Title - Sujet Nouveau havre à Harrington Harbour	
Solicitation No. - N° de l'invitation F3731-170101/A	Amendment No. - N° modif. 009
Client Reference No. - N° de référence du client F3731-170101	Date 2017-11-27
GETS Reference No. - N° de référence de SEAG PW-\$QCM-032-17241	
File No. - N° de dossier QCM-7-40184 (032)	CCC No./N° CCC - FMS No./N° VME
Solicitation Closes - L'invitation prend fin at - à 02:00 PM on - le 2017-11-29	Time Zone Fuseau horaire Heure Normale du l'Est HNE
F.O.B. - F.A.B. Plant-Usine: <input type="checkbox"/> Destination: <input checked="" type="checkbox"/> Other-Autre: <input type="checkbox"/>	
Address Enquiries to: - Adresser toutes questions à: Girard, Isabelle	Buyer Id - Id de l'acheteur qcm032
Telephone No. - N° de téléphone (418) 649-2847 ()	FAX No. - N° de FAX (418) 648-2209
Destination - of Goods, Services, and Construction: Destination - des biens, services et construction:

AMENDMENT 009

Title: Development of a Fishing Harbour, Harrington Harbour

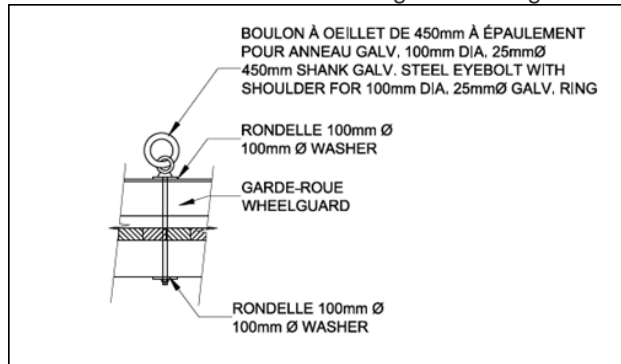
- Question 84 :**
- a. Are there wintering anchor rings to be provided for the existing pontoons and if so, how much by pontoon?
 - b. Are there wintering rings for the new pontoons and if so, how much is there for each pontoon?
 - c. In the event of an affirmative answer to question a - and / or b - could you provide us with the details of the wintering ring?

- Answer 84 :**
- a. Yes there are two wintering anchor rings per existing floating dock.
 - b. No, there is no anchor ring for the new docks.
 - c. Here is the detail of the wintering anchor ring.
